Access Compliance Report

Public Rights-of-Way

| Intersection ID: 27772 | Main Street: BRIARWICK_LN | Cross Street: NORTH_COMMUNITY_HOUSE_RD | Location: SE |
| ADA ID: 6C7040CD9717 | Ramp Type: Perp | Initial Pass/Fail: Fail | Overall Compliance: No |

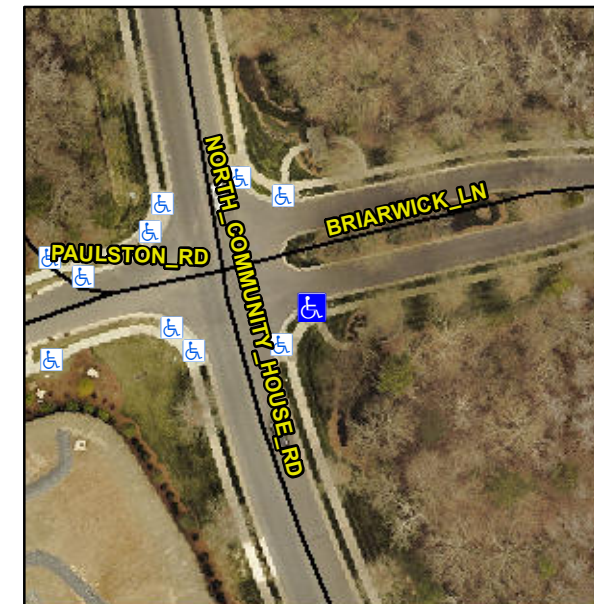
R304.2.2, R304.5.3

| Compliance | Description | Data | Compliance | Description | Data |
|------------|-----------------------|-------|------------|-----------------------------|------|
| N/A | Ramp Length (in) | 106.0 | No | Ramp Slope (%) | 11.7 |
| Yes | Ramp Width (in) | 49.0 | No | Ramp XSlope (%) | 8.3 |

Remove & Replace Entire Ramp.
